DART SERVICE INSTRUCTION

TO AMEND INSTALLATION INSTRUCTIONS IIN-D407-781-1 REV E AND INSTRUCTIONS FOR CONTINUED
AIRWORTHINESS ICA-D407-781 REV 4

REF CANADIAN STC: SH08-60
FAA STC: SR02726NY
EASA STC: EASA.IM.R.S.01541

A	NEW RELEASE	DB	13.04.11
REV.	DESCRIPTION	BY	DATE
DESIGN	DB	DART AEROSPACE LTD	
DRAWN	DB	HAWKESBURY, ONTARIO, CANADA	
CHECKED	A.P.	DRAWING NO.	REV. A
MFG. APPR.	N/A	DSI 9651	SHEET 1 OF 2
APPROVED	<i>[Signature]</i>	TITLE	SCALE
DE APPR.	<i>[Signature]</i>	FLOOR PROTECTOR INSTALLATION	NTS
DATE	13.04.11	COPYRIGHT © 2013 BY DART AEROSPACE LTD THIS DOCUMENT IS PRIVATE AND CONFIDENTIAL AND IS SUPPLIED ON THE EXPRESS CONDITION THAT IT IS NOT TO BE USED FOR ANY PURPOSE OR COPIED OR COMMUNICATED TO ANY OTHER PERSON WITHOUT WRITTEN PERMISSION FROM DART AEROSPACE LTD.

FIGURE 1: FLOOR PROTECTOR INSTALLATION

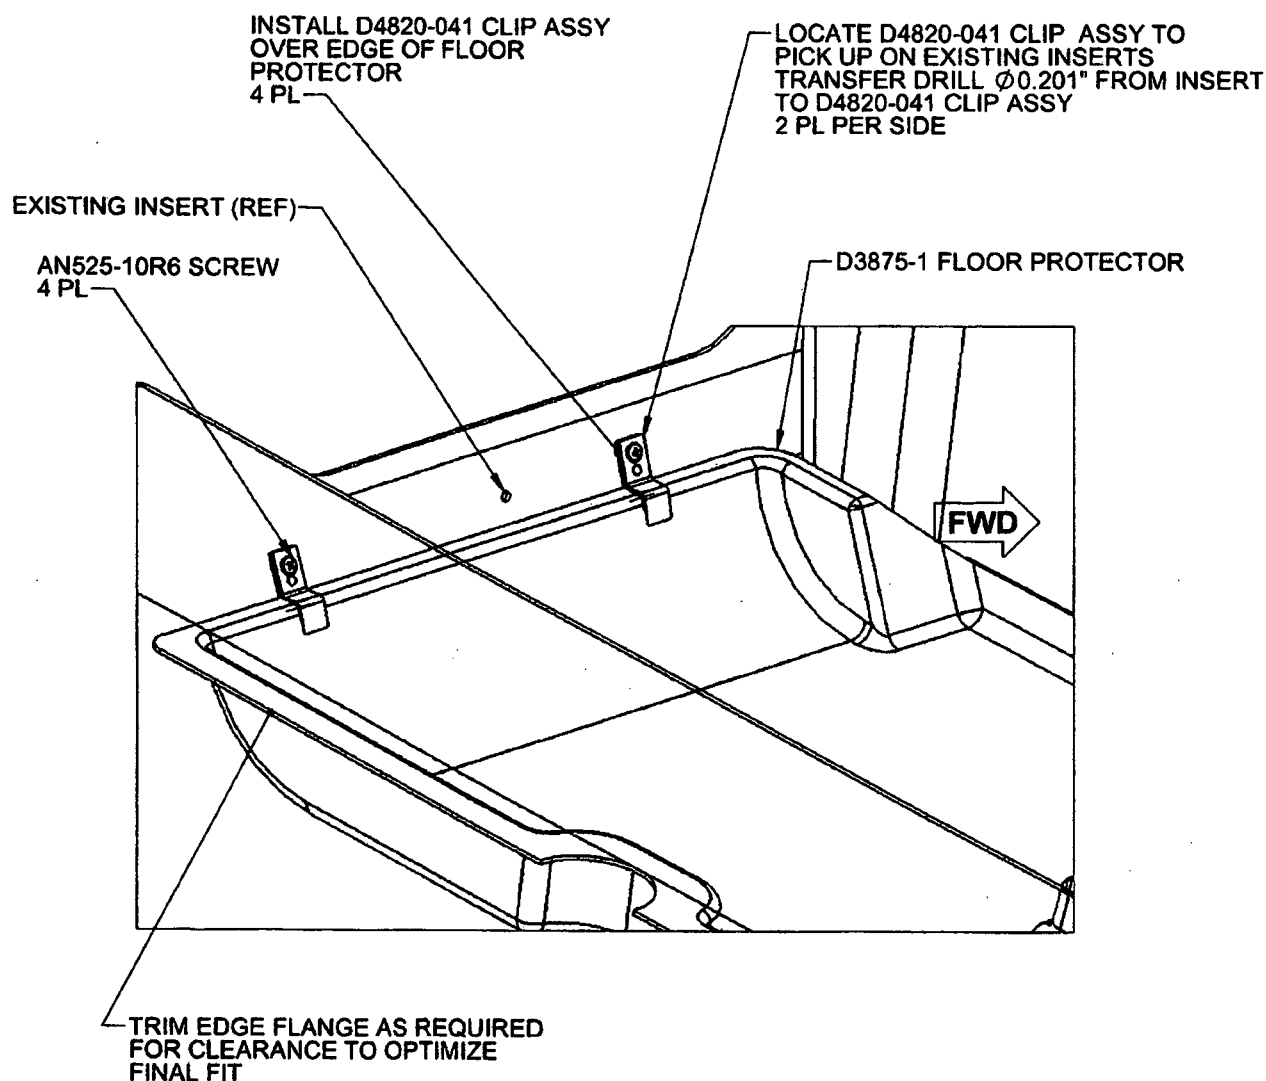
The purpose of this Dart Service Instruction (DSI) is to provide an alternate method of installing the D206-781-021 Floor Protector Kit when it is installed on aircraft without carpets.

- 2.1 Position the D3875-1 Floor Protector in the passenger area, trimming the edge flanges, as required, for clearance around obstacles and/or to optimize the fit. Ensure there is no debris beneath the protector.

- 2.2 Select the best positions for the D4820-041 Clips to pick up on the existing inserts (2 per side). Press down firmly on the floor protector to ensure it is in full contact with the aircraft floor and transfer mark the hole locations to the D4820-041 Clips.

- 2.3 Drill out the marked holes to $\varnothing 0.201$ and deburr.
- 2.4 Install the D4820-041 Clips (2 per side) using AN525-10R6 screws and secure the D3875-1 Floor Protector. The flat portion of the D4820-041 Clip Assy should slip behind the D3875-1 Floor Protector. Torque the screws to 15-25 in-lbs (1.7-2.8 N-m).

Qty	Part Number	Description
X	D206-781-021	FLOOR PROTECTOR KIT (PASSENGER CABIN)
1	D3875-1	FLOOR PROTECTOR, PASSENGER
2	D3934-041	CLIP ASSY
4	D4820-041	CLIP ASSY
4	AN525-10R6	SCREW
2	D3800-1-100-500	LOOP STRIP
2	D3800-3-100-500	HOOK STRIP

Qty	Part Number	Description
-021		
X	D206-781-021	FLOOR PROTECTOR KIT (PASSENGER CABIN)
1	D3875-1	FLOOR PROTECTOR, PASSENGER
2	D3934-041	CLIP ASSY
2	AN525-10R6	SCREW
2	D3800-1-100-500	LOOP STRIP
2	D3800-3-100-500	HOOK STRIP
